RE: PRRES20212465
536 SE CARTER RD
LEE'S SUMMIT, MO.

Our firm has been asked to address rough framing inspection items for the home being built at the location listed above. At the time of inspection the home was in a rough framed state. Please find below the inspection item and our firms response.

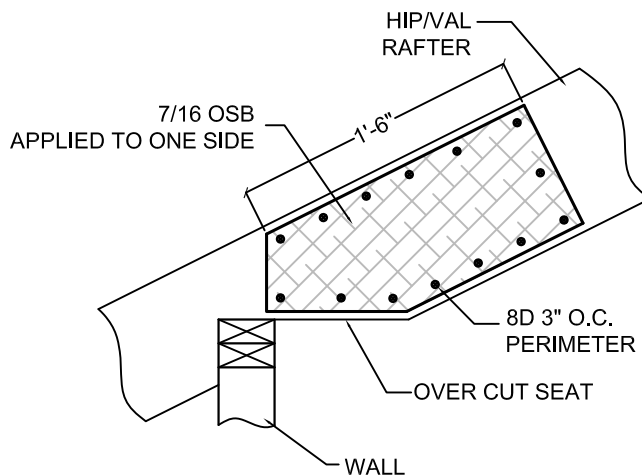
- Provide engineer report or 75% bearing at all roof members on bearing walls
- Address notched valley rafter and bearing
- Address over notched hip and joist at bedroom 2

There are several locations where the hip and valley seat cuts have been over cut to allow clearance. After review of the roof loads our firm has identified the locations (see below marked in red) in need of additional reinforcing to ensure proper transfer of roof loads. The locations marked will be reinforced with a layer of 7/16 OSB attached as shown in the detail below.
